Source: Rapporteur Q14/16

Title: Consensus List for V.152

This document records the current status of the work concerning V.152 (V.VBD) at the conclusion of the November 2009 meeting of Study Group 16.

Figure [X].1 — Fax procedure and echo-canceller status after enabling by V.21 preamble

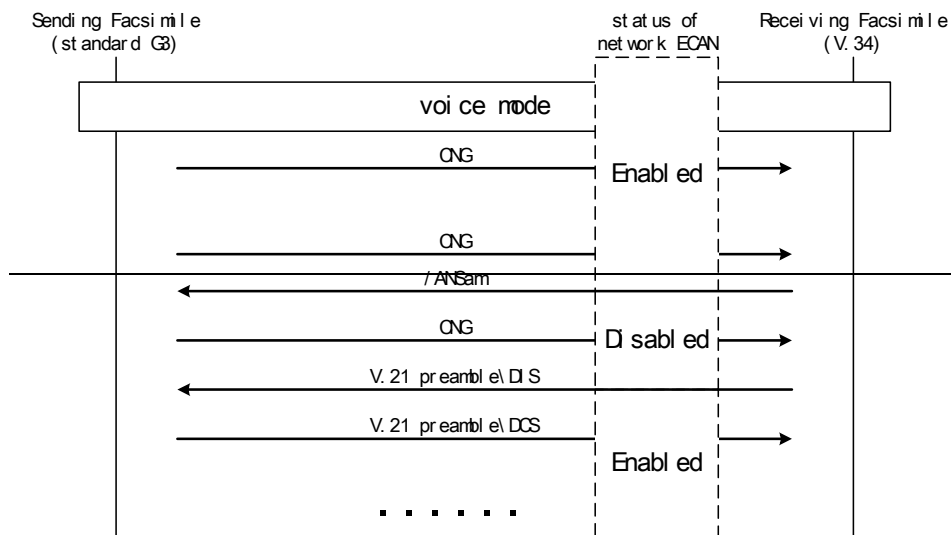
Note: this figure has to be redrawn to include echo-cancellers at both sides of the connection. Also in the figure the word 'disabled' has to be replaced with Tone Disabled State and 'enabled' is replaced with Initial cancelling state.
